Atlanta Avenue Railroad Crossing Improvements Emailed Comments Summary

H:\Windows\OutlookTempFiles\Atlanta Ave - Post-Worshop Comments.docx

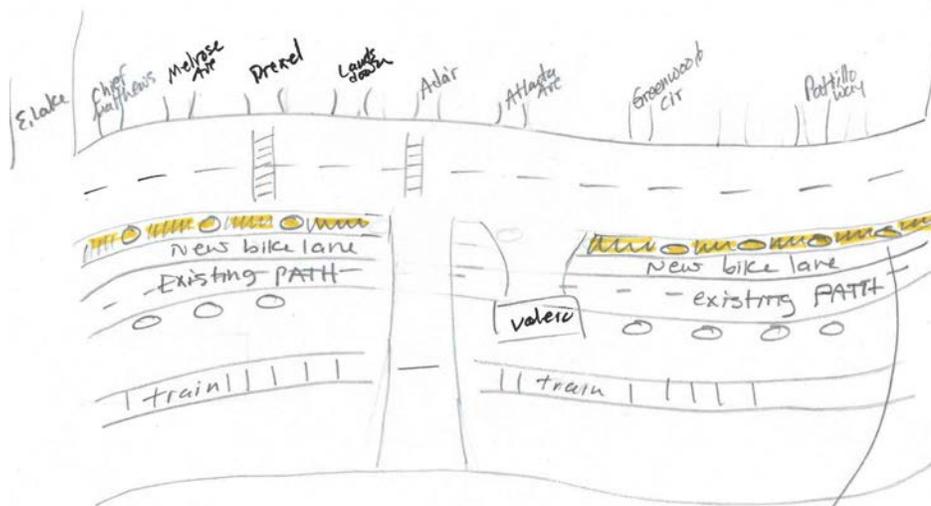
I would like to see a new tree line! A tree line that is exactly where the planters are now. See my drawing attached. Trees would thrive in this section because they would be inside the current curb line, and free to grow up, above the power lines. In addition, this would make Howard simply gorgeous. It would calm traffic even more. I would hope you would have long sections of soil for them to grow in, vs the little squares that are typically used in cities to contain trees. It would be amazing if you planted multiple kinds of over story trees, like large leaf Oaks and tulip poplars, not just pin oaks.

I hope my rough drawing helps illustrate my idea.

Can we replace the planters with permanent tree plantings? These trees would be able to flourish without power lines above. This would make Howard beautiful.

The landscaping treatment of the corridor will depend on the preference of the community and feasibility. One of the concepts we showcased during the Traffic Calming session of the virtual workshop (Option D – Planter Islands) includes planter islands being installed in the midblock areas of Howard Avenue. These would be permanent features and their size and type will be dependent on their ability to grow and flourish in the median provided. We will consider your suggestions for the trees as we move into the design phase.

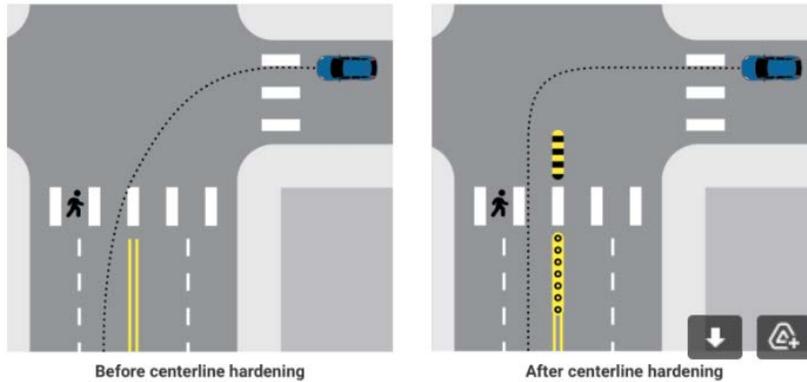
We are excited by this opportunity to build upon this success by making it even safer to access for Decatur citizens young and old. The new plans, however, call for a dramatic widening of the roadways on both sides of the railway tracks to make room for turning lanes. Both W. Howard and College Avenues would be widened to four lanes at the intersection, with dedicated turn lanes. Wide intersections of this type, especially when designed with dedicated turn lanes, tend to be very dangerous for pedestrians and people on bikes and in wheelchairs, especially small ones, like children.

We will continue to evaluate the proposed geometry for optimal performance and safety. We will also include truck aprons at turning radii and consider the bulb-out proposed.

Truck Corner Apron Examples

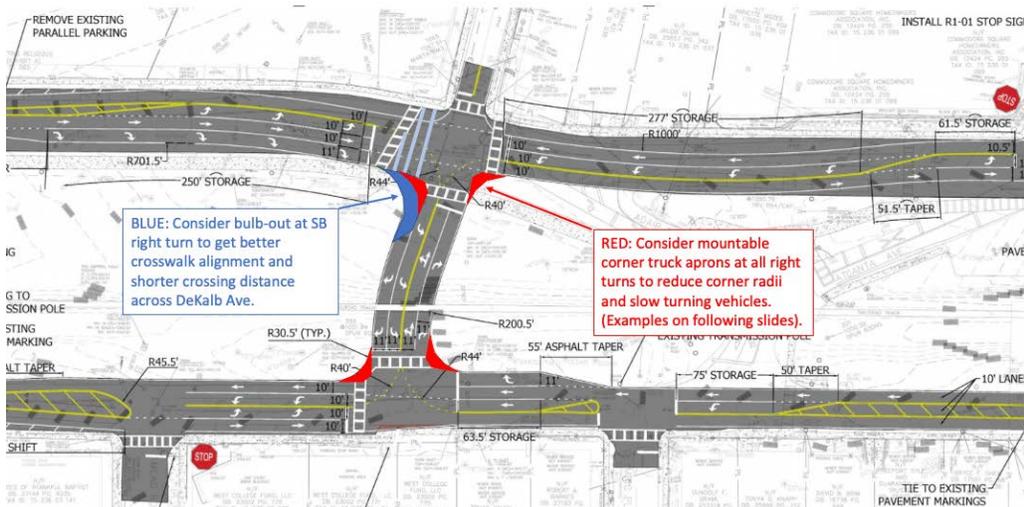
Centerline hardening for left-turning vehicles forces turning vehicles to turn left at a tighter angle and improves safety. Here is an example.
